Flex Fuel Extended Crank Due to Alcohol Density Calculation

Service Category Engine/Hybrid System

REVISION NOTICE

December 11, 2014 Rev2:

Figure 1. Location of Authorized Modifications Label on 2012 – 2015 Sequoia and Tundra

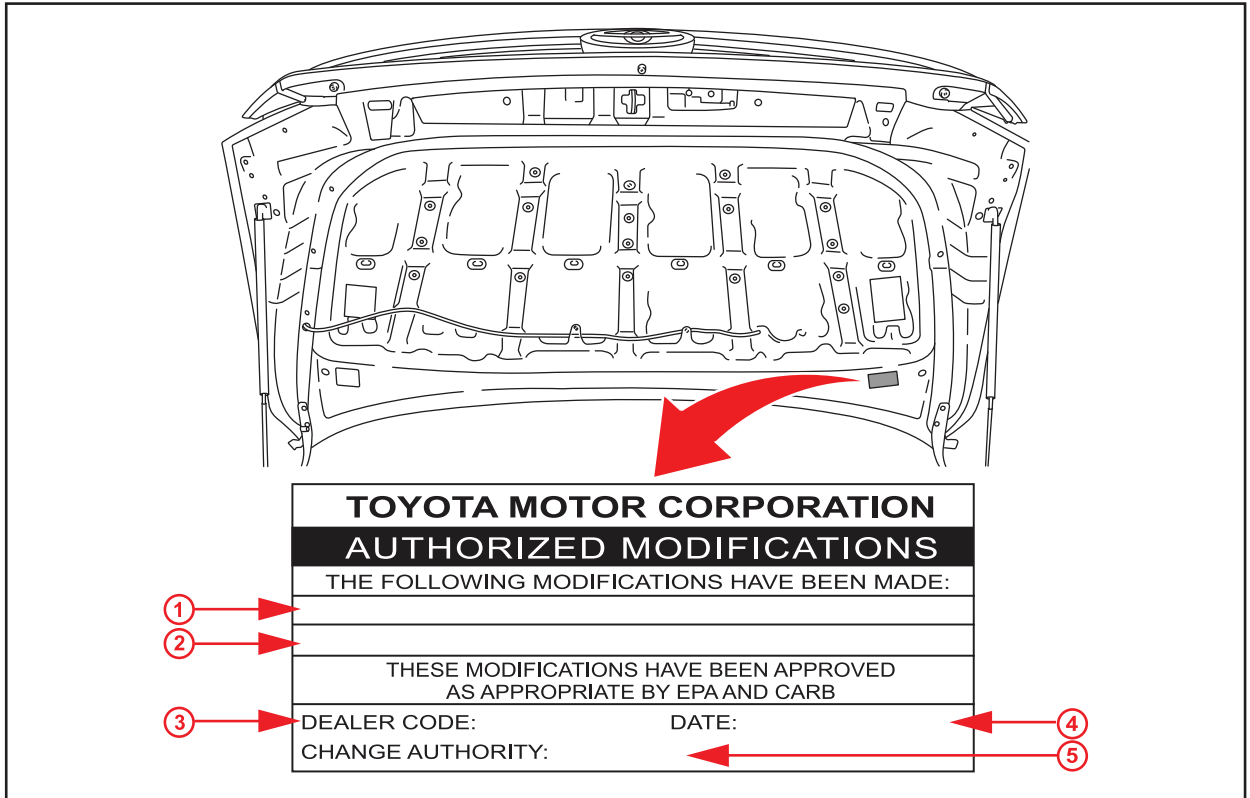
4. Check for the Authorized Modifications Label affixed to the vehicle in the location shown in Figure 1. Confirm if the ECM (PCM) calibration has been updated. If the calibration ID listed is NOT the latest ECM (PCM) calibration — go to step 5.

- B. Affix the Authorized Modifications Label to the vehicle at the location shown in Figure 1. The Authorized Modifications Label is available through the MDC, P/N 00451-00001-LBL.
